BULLETIN # 182-B

CP38 SYNCRO-PULSE CDT

MODIFICATION TO CP38-16 WIRE GAS CONTROL BOARD FOR W37

Fig 1 CP38-16 (early version) pcb

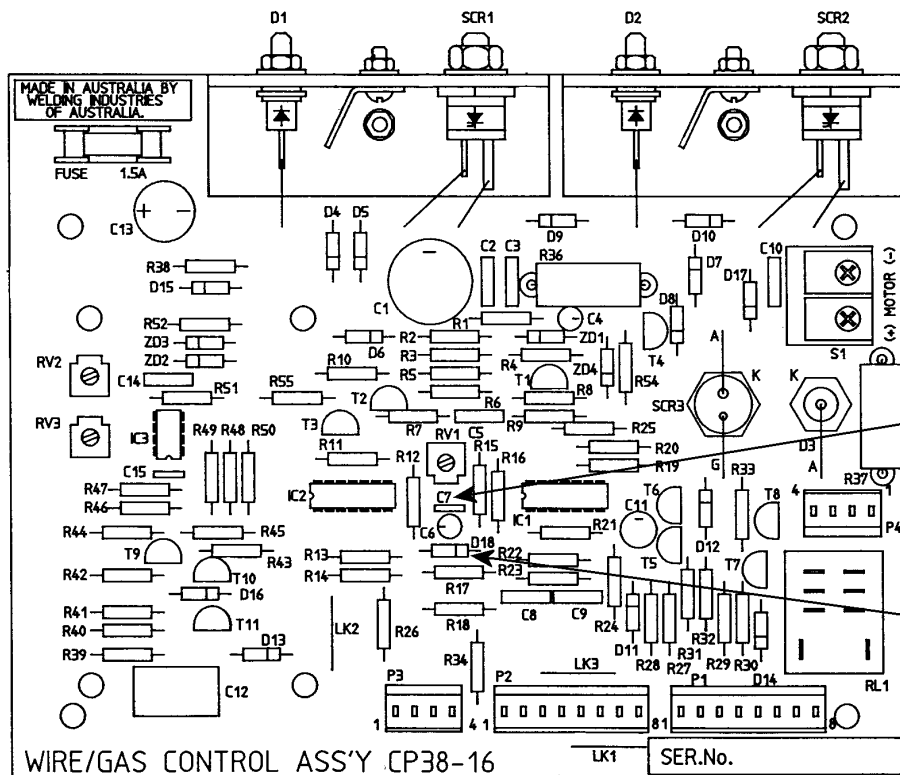
C7, remove & replace with 0.1uF, 100v polyester or MKT

D18 (possibly mislabelled as D1) Remove completely

Fig 2 CP38-16 (later version) pcb

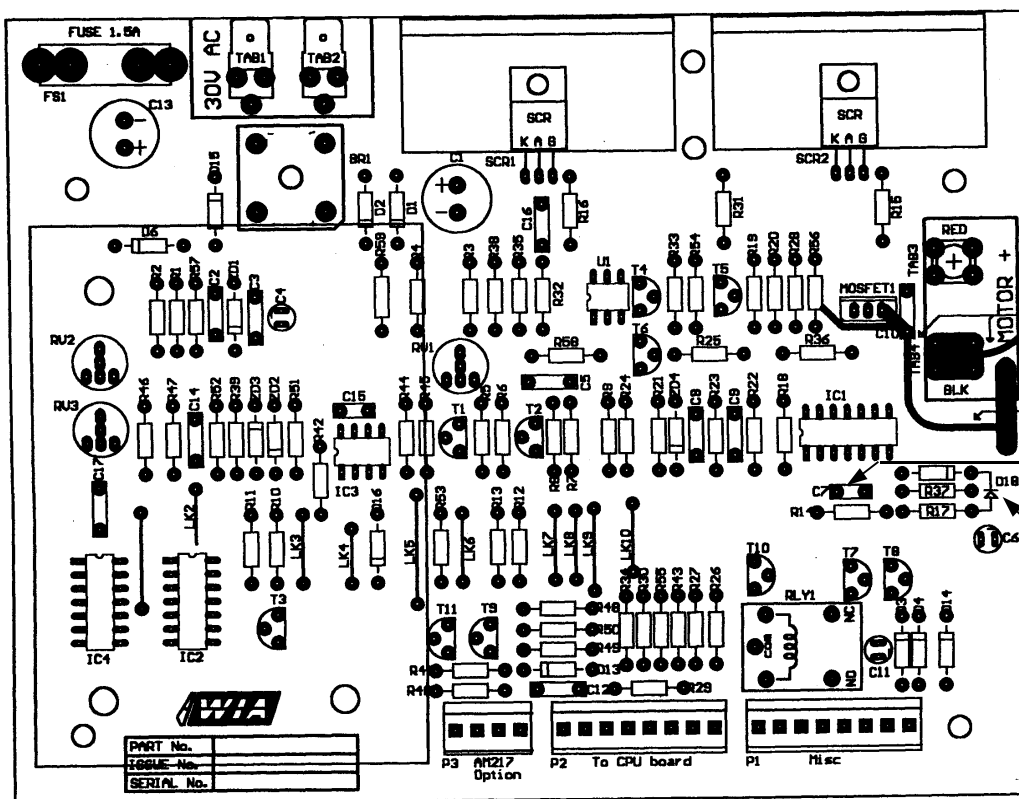
C7, remove & replace with 0.1uF, 100v polyester or MKT

D18, remove completely
